Technical design note

Project name	Dunsbury Park - Plot 5		
Design note title	Reserved Matters - drainage condition response		
Document reference	19453-HYD-XX-XX-RP-C-0003		
Author	Alastair Todd		
Revision	P01		
Date	2 August 2023	Approved	☐

This technical note looks to discharge drainage conditions in relation to Reserved Matters application for Phase 1 Plot 5 of APP/17/O1324. This report sets out each condition as worded by Hampshire Lead Local Flood Authority and addressed accordingly.

DRAINAGE LAYOUT
SHEET 1

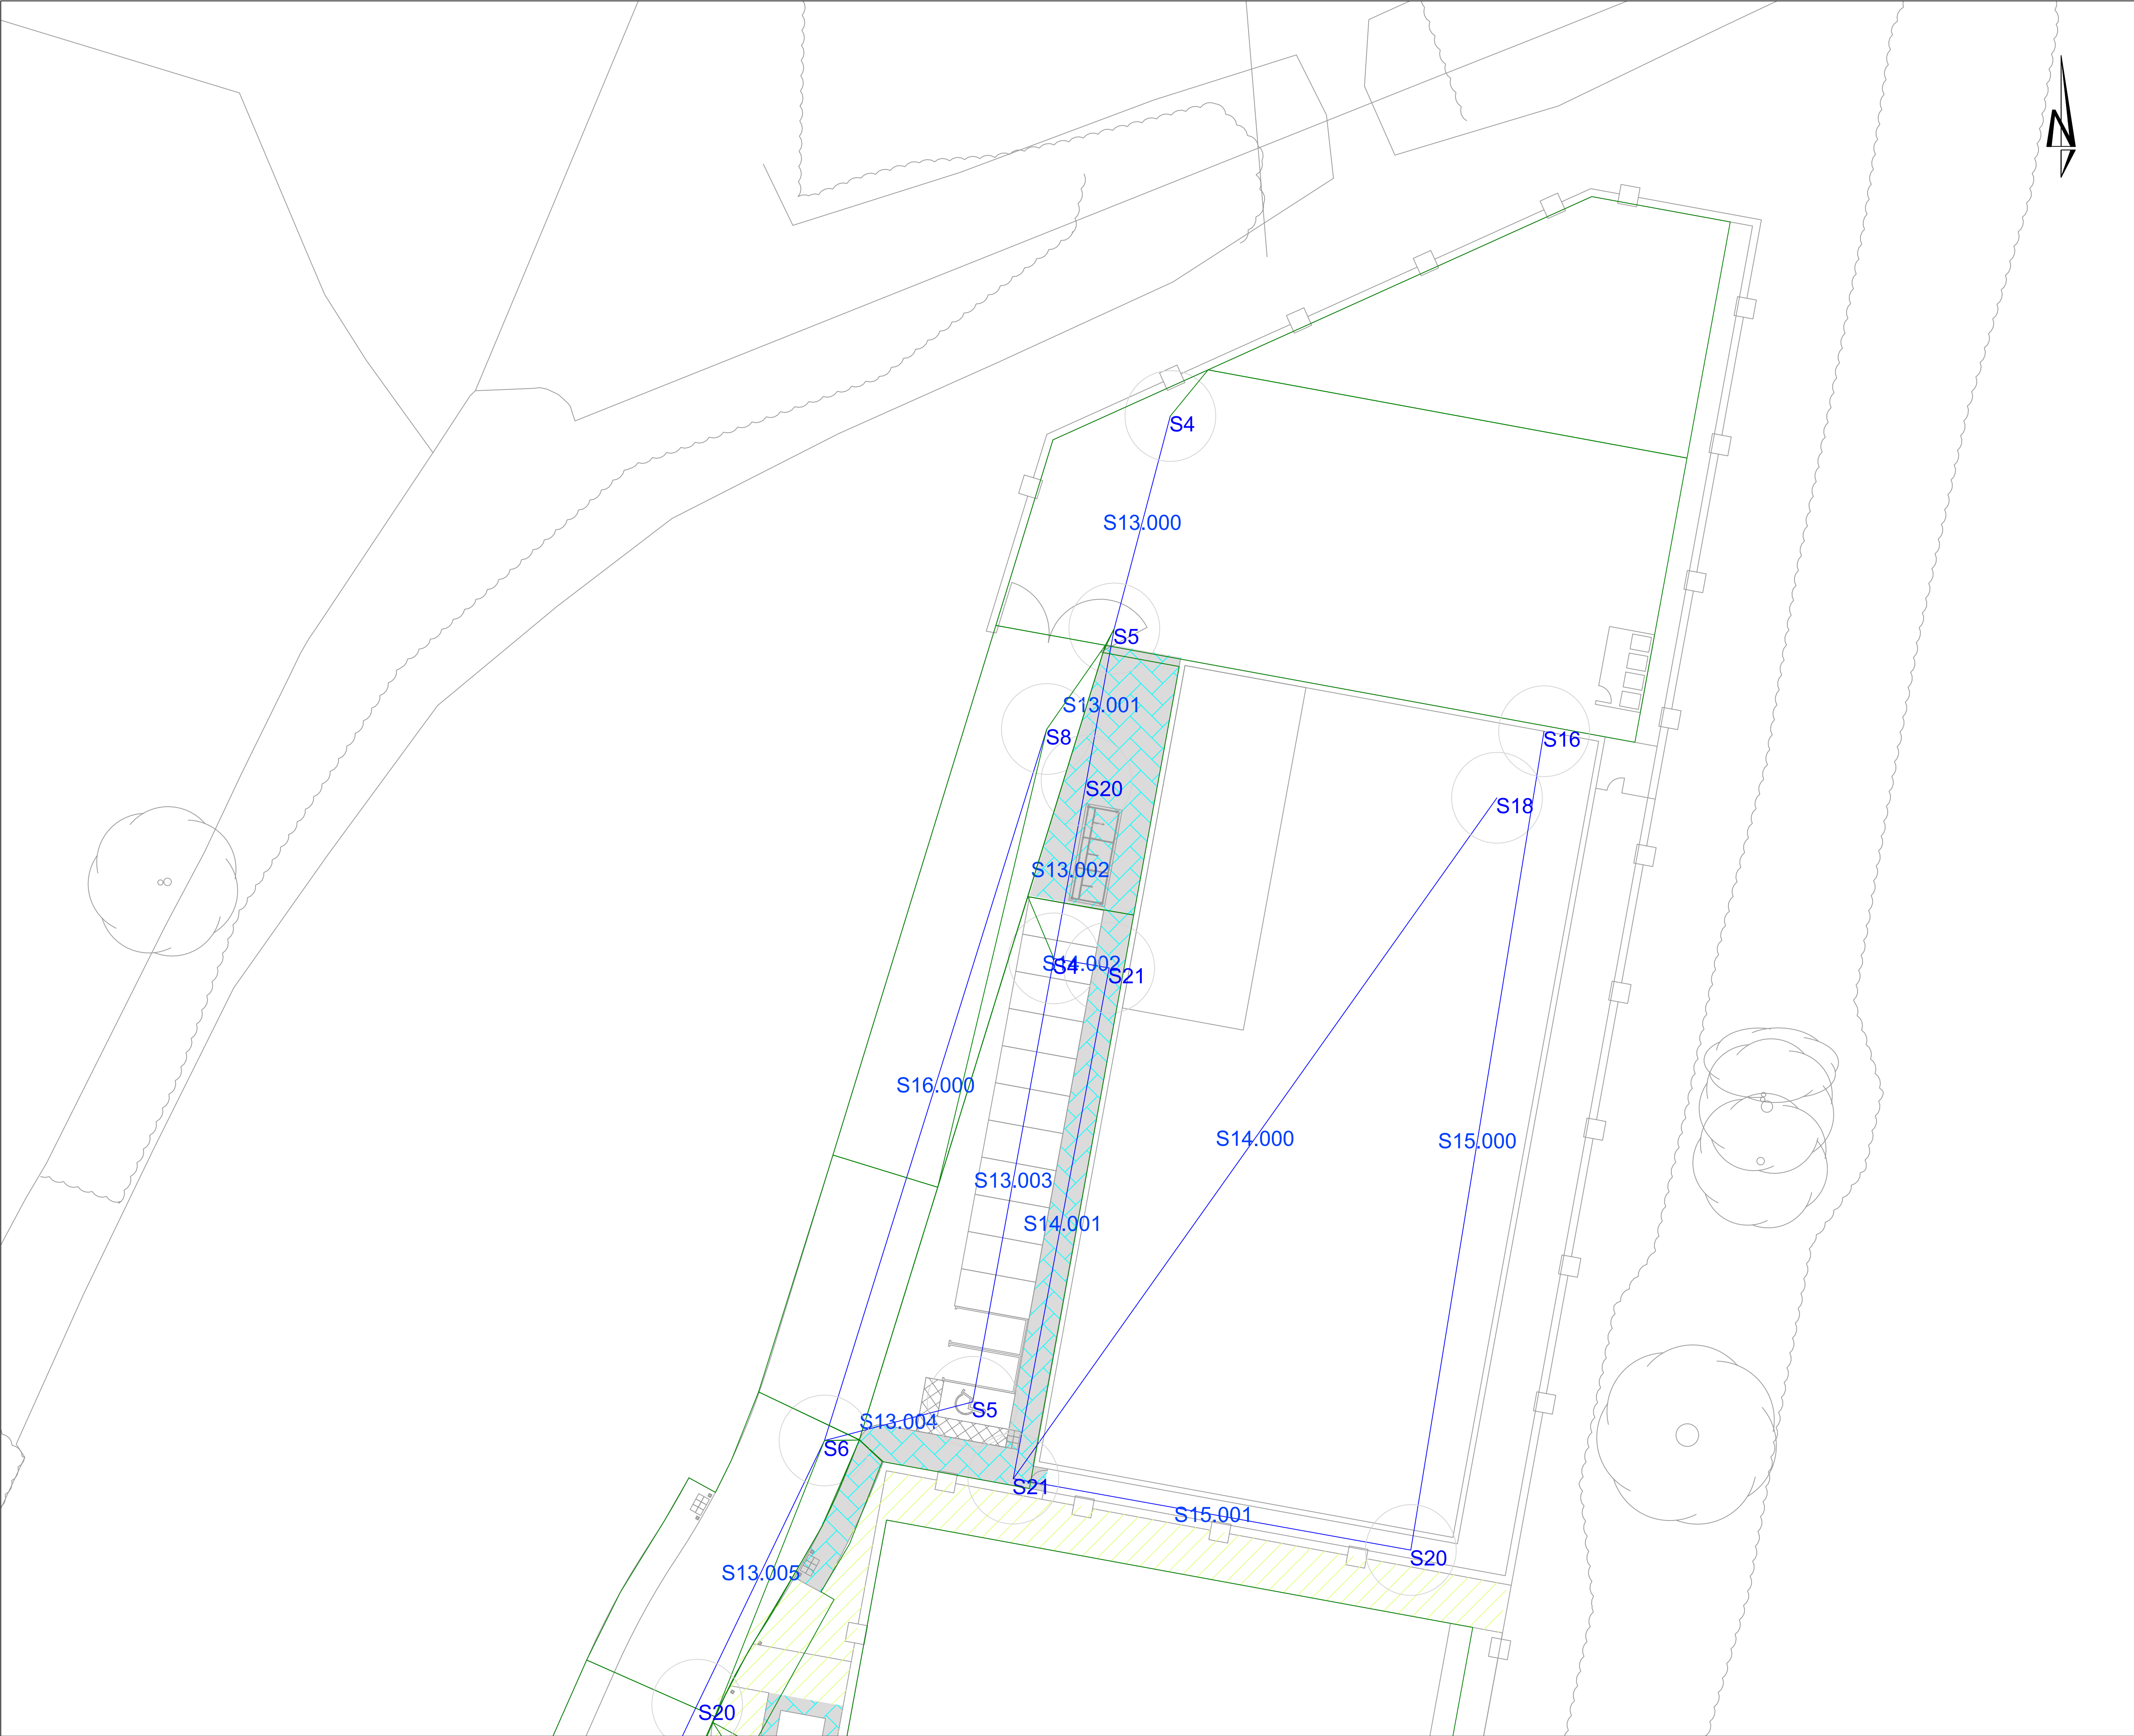
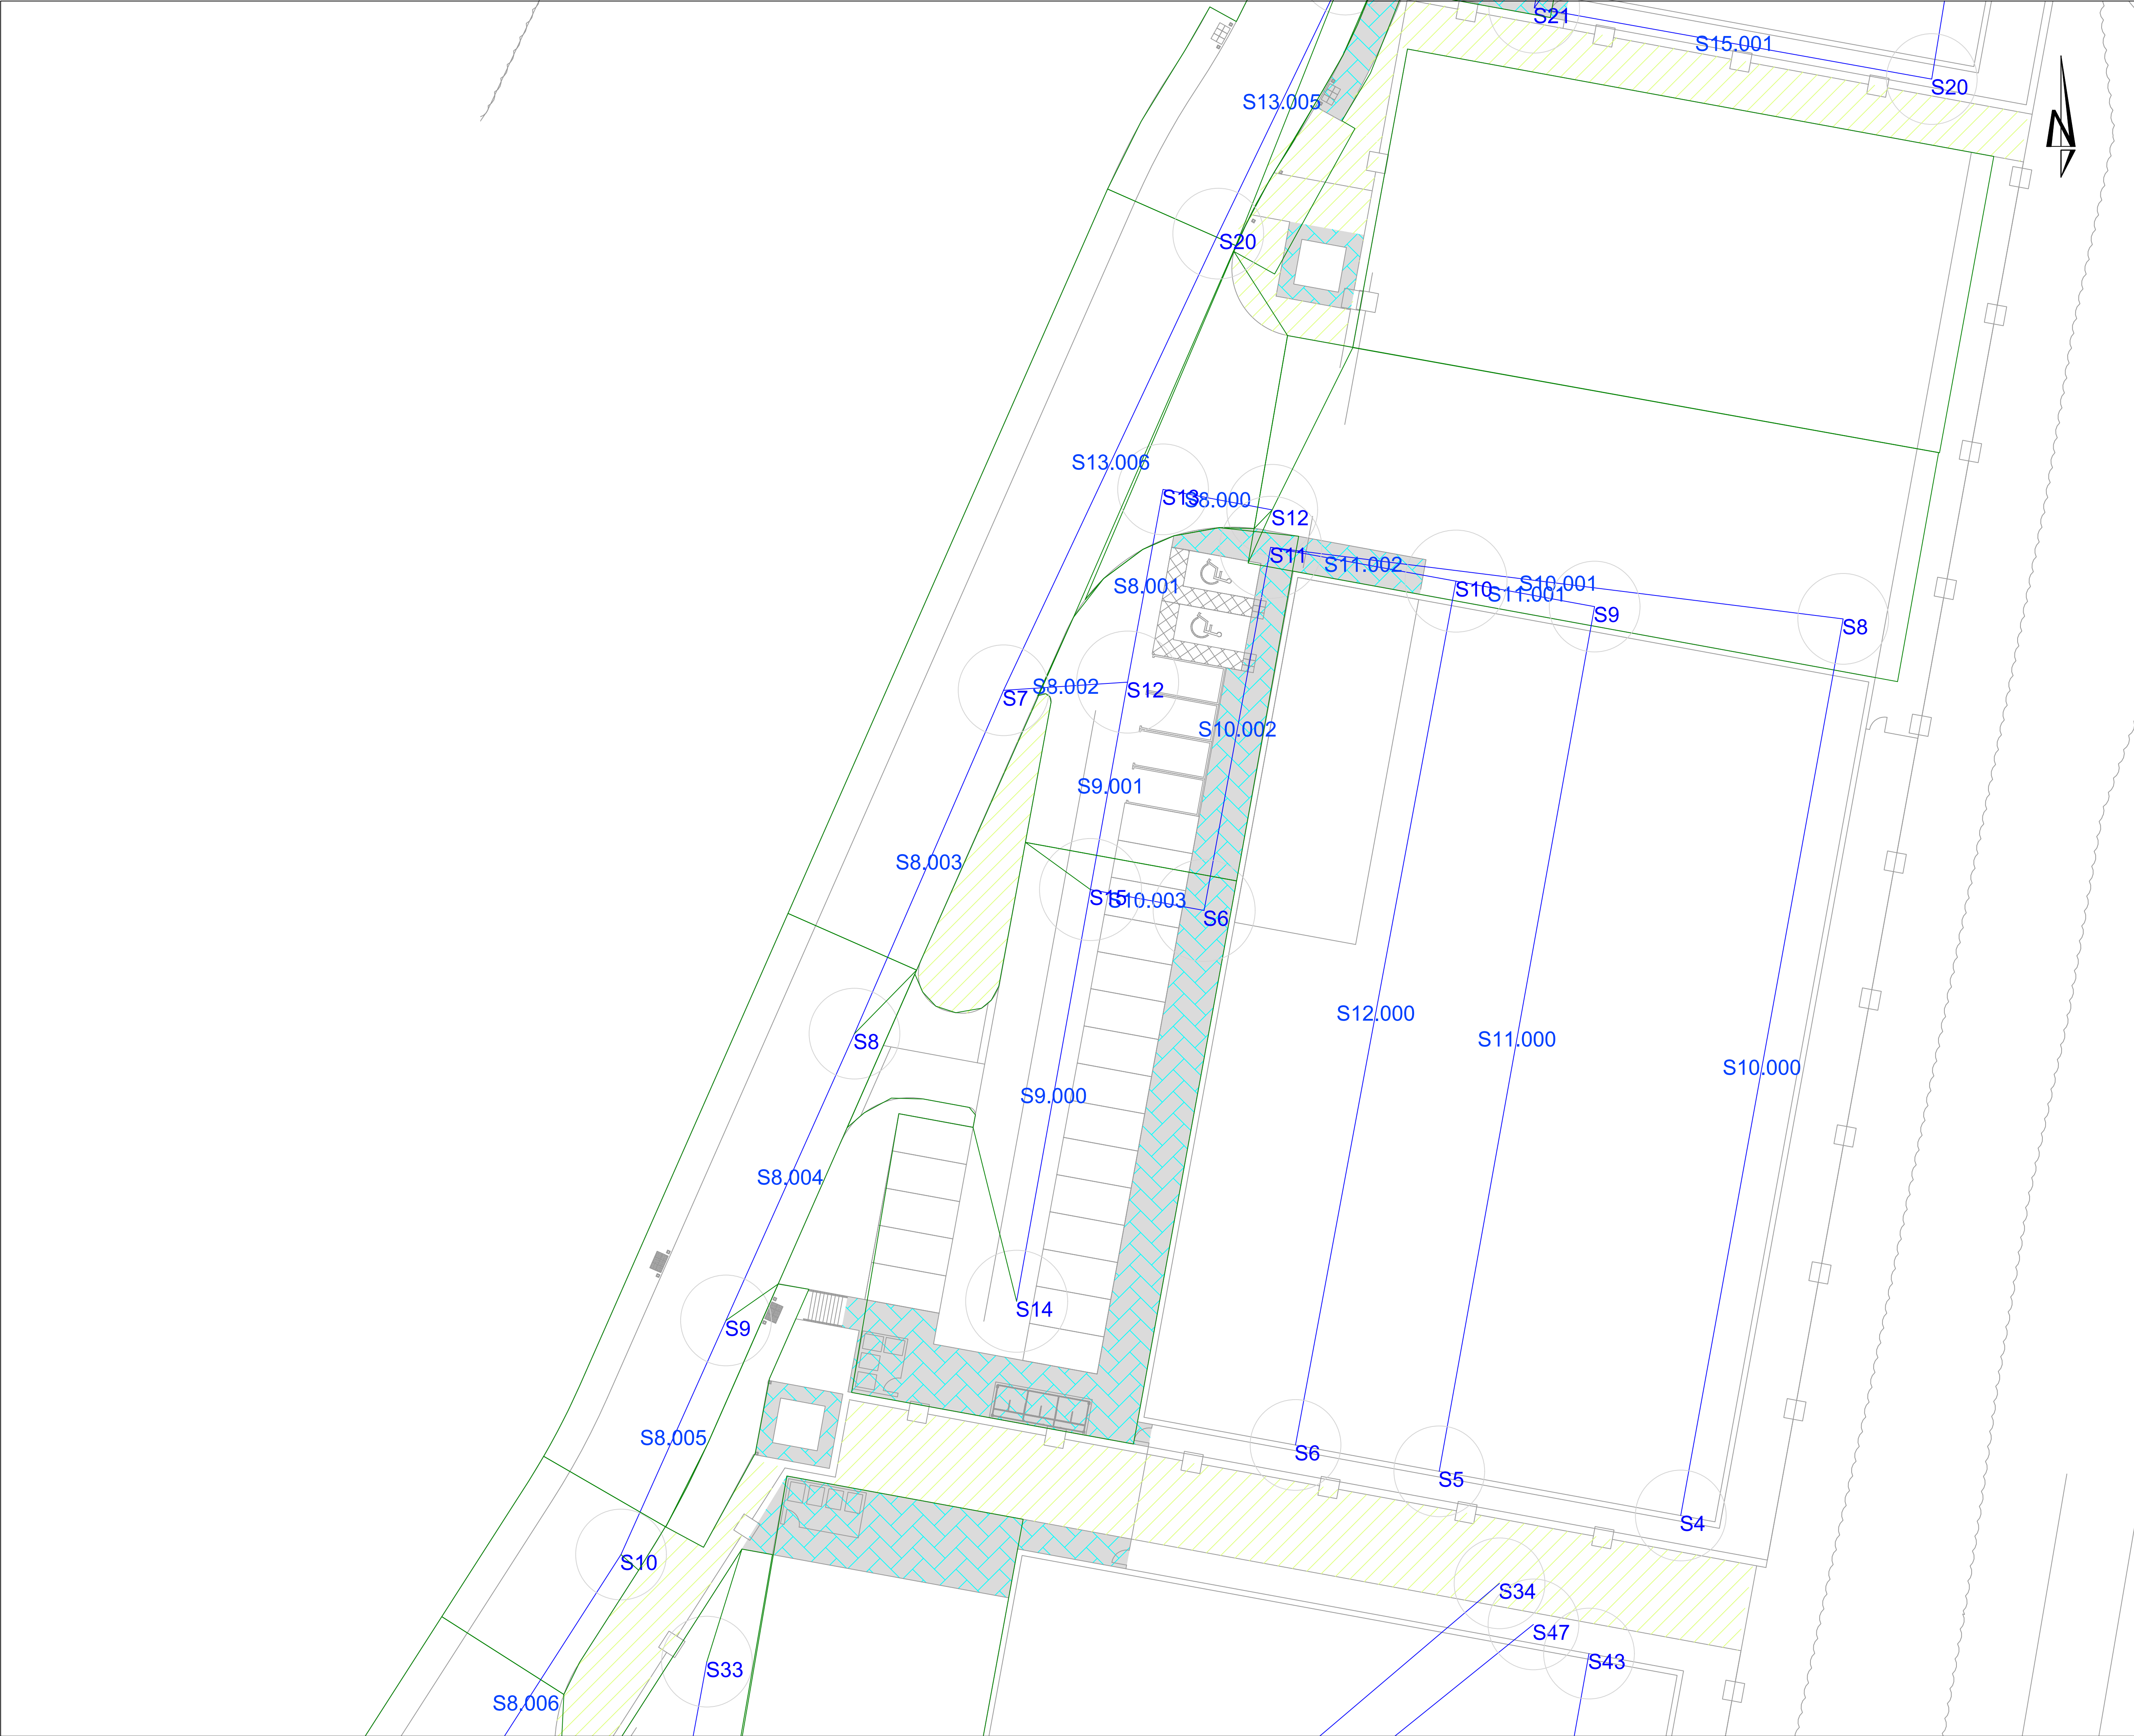
2. Confirmation that flooding modelled during the 1 in 100 year storm event does not occur for the 1 in 30 year event.

3. Clarification over discrepancies between the calculations and drainage layout, especially with regards to the flow control discharge rates.

A new set of modelling has been undertaken to align with contractor requirements, primarily the inclusion of siphonic drainage for the unit roofs. These calculations and pipe layout are included in **Appendix C** and show that no flooding occurs on site in the 1 in 30 year storm event. Any flooding occurring in the 1 in 100 plus climate change event is designed to be retained within car parking areas and diverted away from critical infrastructure.

It should be noted that impermeable areas shown on calculations do not match those shown in Table 1 due to the exclusion of roof areas served by siphonic drainage. Siphonic drainage modelling requires for a discharge rate to be inputted rather than an area attributed to a certain pipe within the network.

The site drawings as shown in **Appendix B** and the pipe layout drawing shown in **Appendix C** show that there are no discrepancies between proposed discharge rates and those modelled.
